UNITED STATES
NUCLEAR REGULATORY COMMISSION
WASHINGTON, D. C. 20555

SURRY POWER STATION, UNIT NO. 1

AMENDMENT TO FACILITY OPERATING LICENSE

Amendment No. 147
License No. DPR-32

Figure 3.1-1 RCS Heatup Limitations

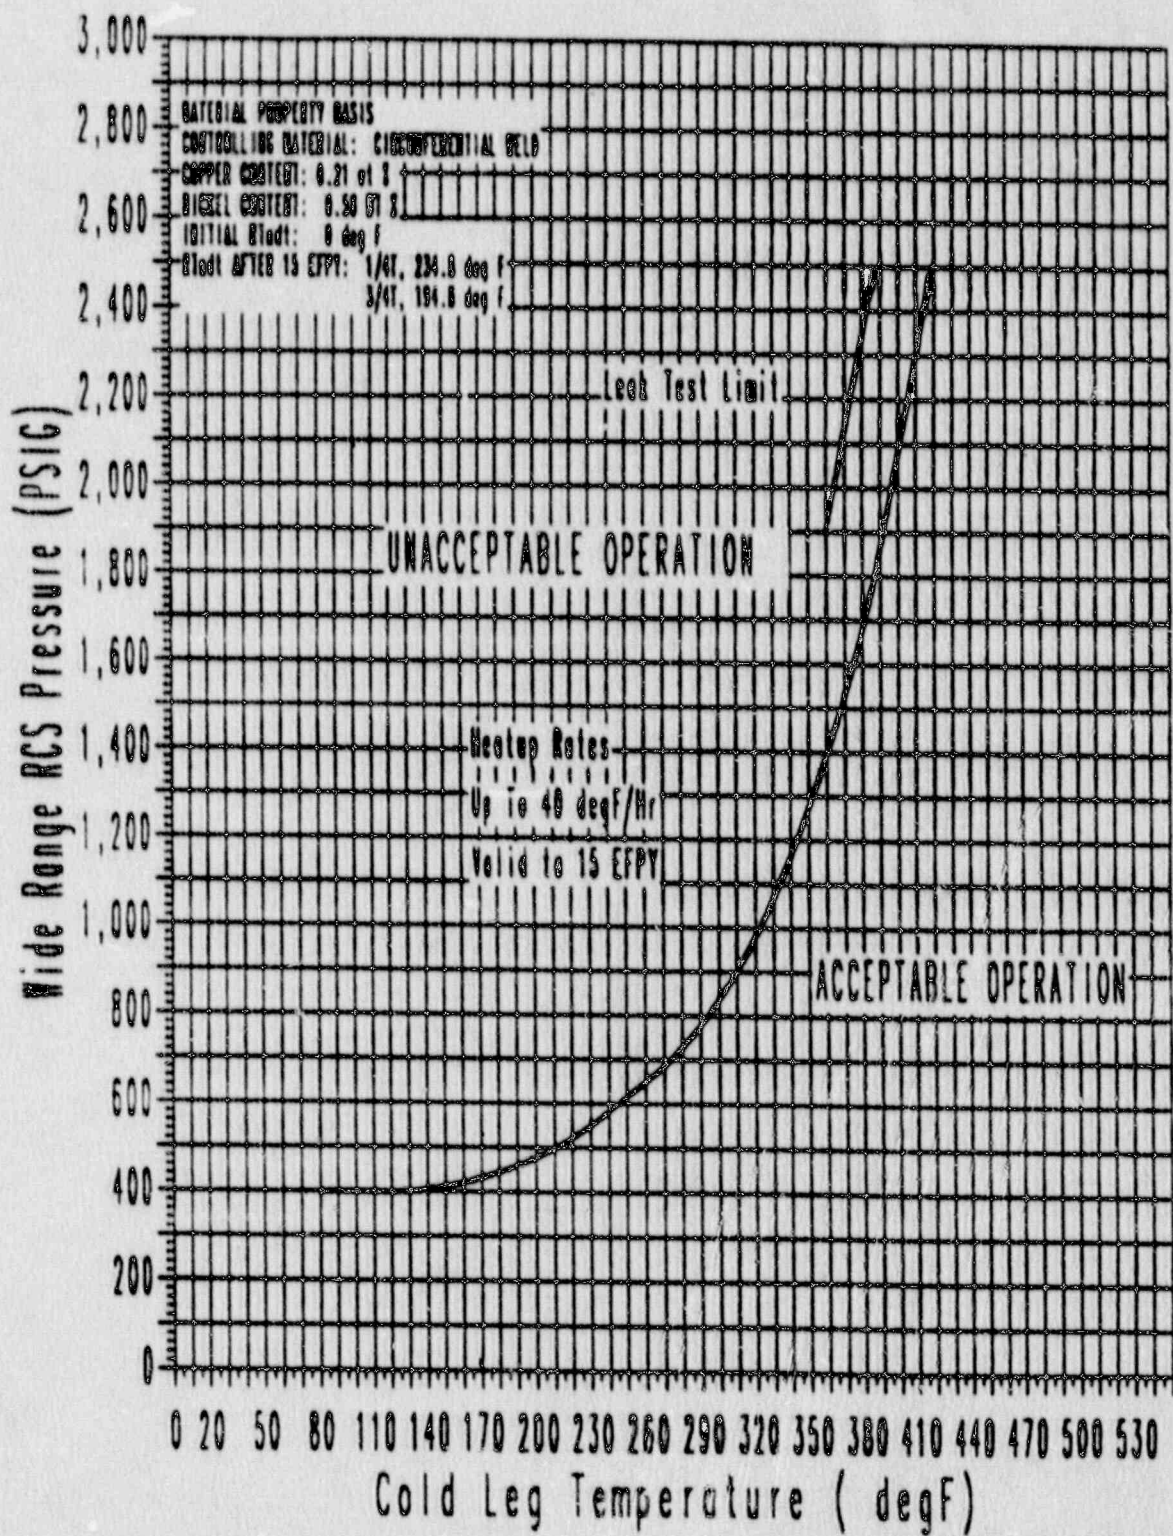
1. Unit 1 and Unit 2 reactor coolant temperature and pressure and the system heatup and cooldown (with the exception of the pressurizer) shall be limited in accordance with TS Figures 3.1-1 and 3.1-2.

Figure 3.1-1 may be used for heatup rates of up to 40°F/hr.

The heatup limit curve, Figure 3.1-1, is a composite curve which was prepared by determining the most conservative case, with either the inside or outside wall controlling, for any heatup rate up to 40°F per hour. The cooldown limit curves of Figure 3.1-2 are composite curves which were prepared based upon the same type analysis with the exception that the controlling location is always the inside wall where the cooldown thermal gradients tend to produce tensile stresses while producing compressive stresses at the outside wall. The heatup and cooldown curves were prepared based upon the most limiting value of the predicted adjusted reference temperature at the end of .5 EFPY. The adjusted reference temperature was calculated using results from a capsule removed after the eighth cycle. The results are documented in WCAP 11415 and WCAP 11492-1 for Unit 1 and WCAP 11499 and WCAP 11505 for Unit 2.

Figure 3.1-3 Fast Neutron Fluence ($E > 1$ MeV) as a Function of Full Power Service Life (EFPY) for Surry Unit 1

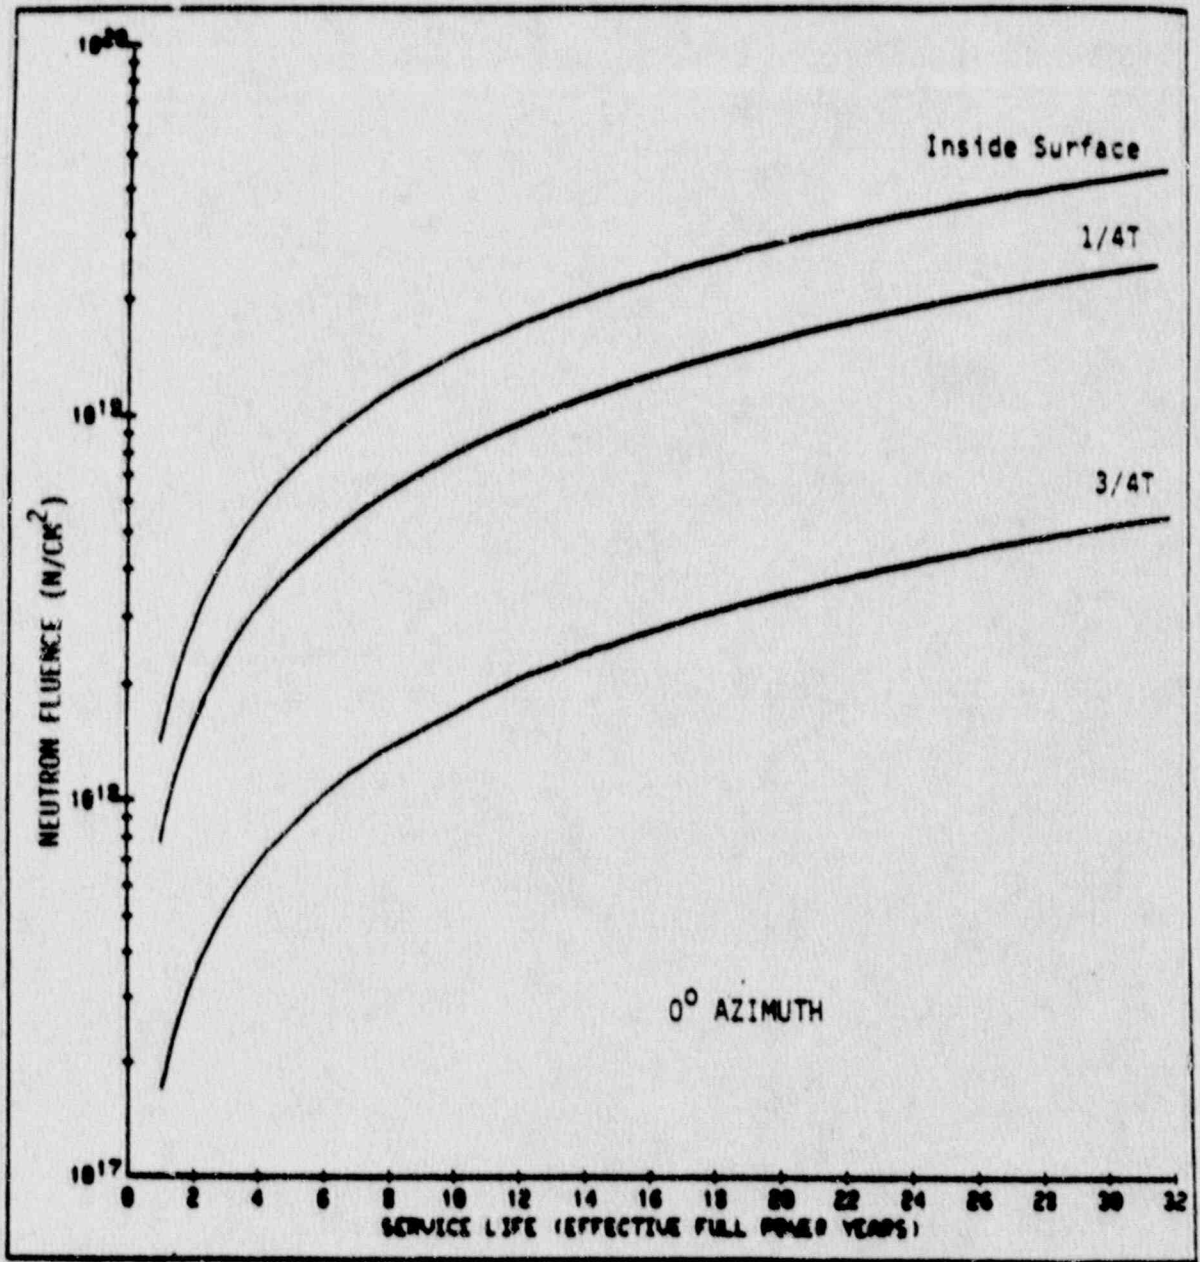
TS 3.1-6
TS 3.1-7
TS 3.1-8
TS 3.1-9
TS 3.1-10
TS 3.1-11
TS 3.1-12
TS 3.1-23
TS 3.1-25
Figure 3.1-1
Figure 3.1-2
Figure 3.1-3
--
--
--
TS 4.2-4

TS 3.1-6
TS 3.1-7
TS 3.1-8
TS 3.1-9
TS 3.1-10
TS 3.1-11
TS 3.1-12
TS 3.1-23
TS 3.1-25
Figure 3.1-1
Figure 3.1-2
Figure 3.1-3
Figure 3.1-4
Table 3.1-1
Table 3.1-2
TS 4.2-4
